MANDATORY SERVICE BULLETIN NO. MSB-62-051 REV. 0

Replacement of Main Landing Gear and Nose Landing Gear retaining rings.

WORK INSTRUCTION WI-MSB-62-051 REV. 0

Figure 1. MLG Retaining rings.

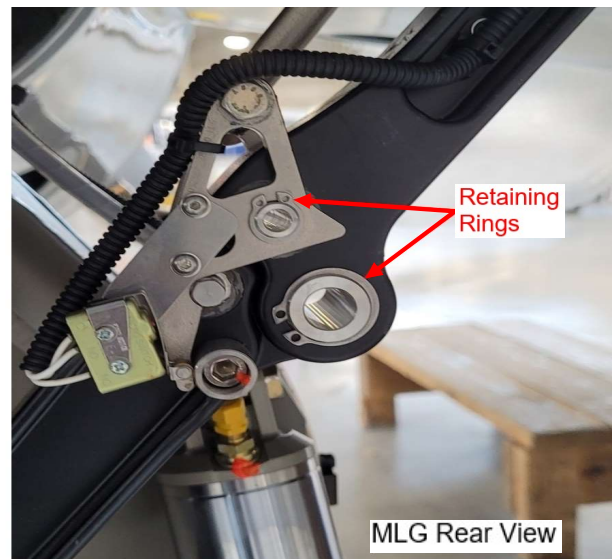
It was discovered that the main and nose landing gear braces of some DA 62 aircraft had retaining rings with insufficient level of corrosion resistance being installed. This may cause the retaining rings to corrode, sustain damage, or fail (crack). If not corrected, this may lead to failure of the landing gear. This Service Bulletin describes the replacement of those retaining rings.

3. Remove the retaining rings from the MLG legs and NLG leg as per figures above (Refer to Figures 1 and 2 for location).
4. Clean the grooves of the bearing shafts. Inspect the folding stay and bearing shafts for general condition before installing the new retaining rings.

5. Install the new retaining rings (items 1 and 2 for front and rear of the MLG and items 1 and 3 for left and right side of the NLG). Make sure the retaining rings properly engage into the grooves of the bearing shafts.
